UNITED STATES PATENT AND TRADEMARK OFFICE

APPLICATION NO.	FILING DATE	FIRST NAMED INVENTOR	ATTORNEY DOCKET NO.	CONFIRMATION NO.
10/632,724	08/01/2003	Joseph Auriemma	0302	2784

Office Action Summary

DETAILED ACTION

Fig. 4

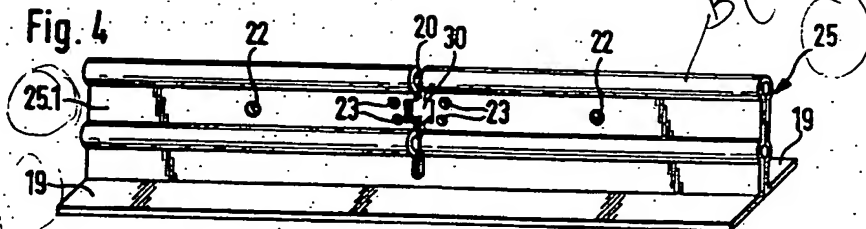
Boegle teaches supporting rail for lower ceilings and attachments comprising an invert T cross-section beam 25. The beam 25 having a bulb B at the top (see attachment of figure 4), a vertical web 25.1, and horizontal flanges 19, cutouts 20, 20.1, 20.2 spaced along the beam (fig. 5) extending into the bulb B (fig. 4) and the web 25.1 and leaving an intact segment 30 of the bulb above each cutout, a splice plate 35/36, each having two integral portions connected by a step (fig. 7) can be inserted after spreading of the bending cuts 20 into slot shaped supporting rail or beam. Boegle does not teach specifically the splice plate having a slot in one of the portion. Examiner takes Official Notice the fact that the splice plate taught by Boegle would have been obvious functional equivalent to the applicant's splice plate because it would capable performed a similar function such as providing a support to a cutout; thus it would limited the bending to desirable curve (e.g. concave or convex).
